**CCB 7992**

# **Pre and Post Change Summary**

**PCN #: CAAN-10TJFI538**

# Lead Frame Comparison

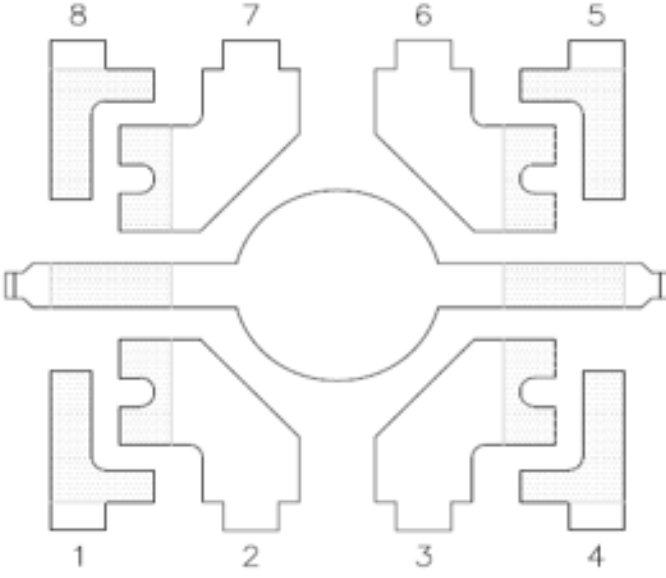
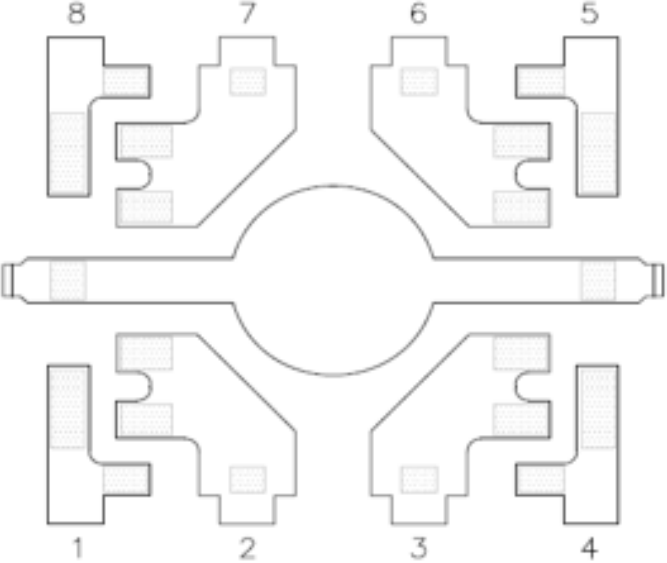
<b>Lead-Frame Material</b>	<b>CDA194</b>	<b>Lead-Frame Material</b>	<b>CDA194</b>
<b>DAP Surface Prep</b>	<b>Ag spot</b>	<b>DAP Surface Prep</b>	<b>Ag selective</b>
